Initial Project Review

Shoreline Substantial Development Permit / Shoreline Conditional Use Permit / Shoreline Variance: Hannula and Beckman

Application Numbers: 895673, 895674, 895675, 897245

Site Plan

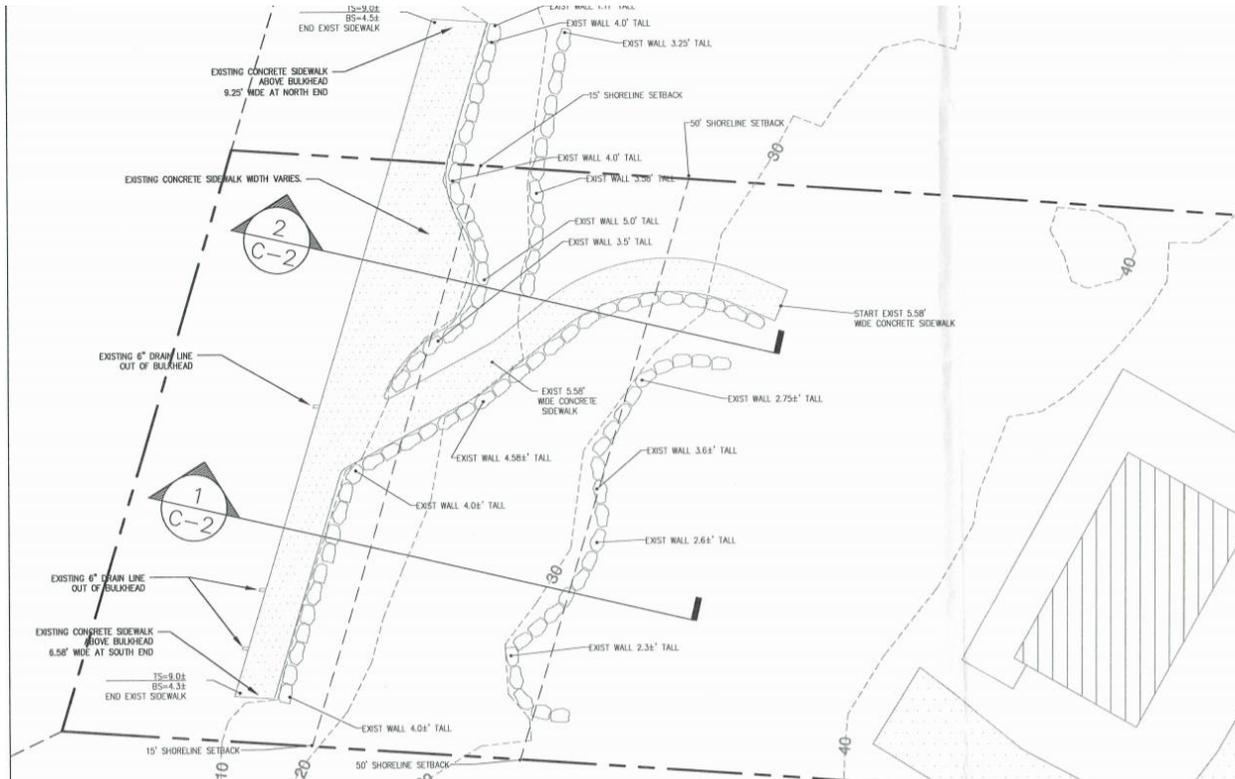
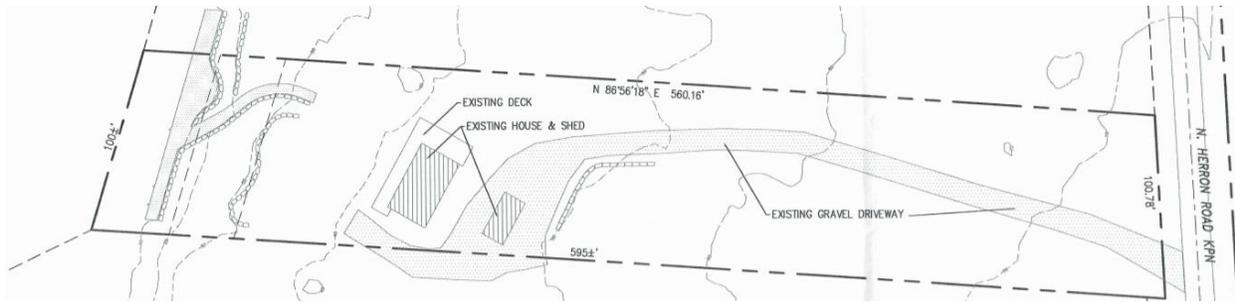
The submitted site plan does not indicate the total impervious coverage of the sites and whether or not it exceeds the maximum impervious coverage of 33.3% as allowed by PCC (within 200 feet of shoreline jurisdiction). Therefore, staff will recommend a condition of approval for the applicants to demonstrate this calculation to be equal or less than the maximum 33.3%, as allowed by Pierce County Code, on each parcel.
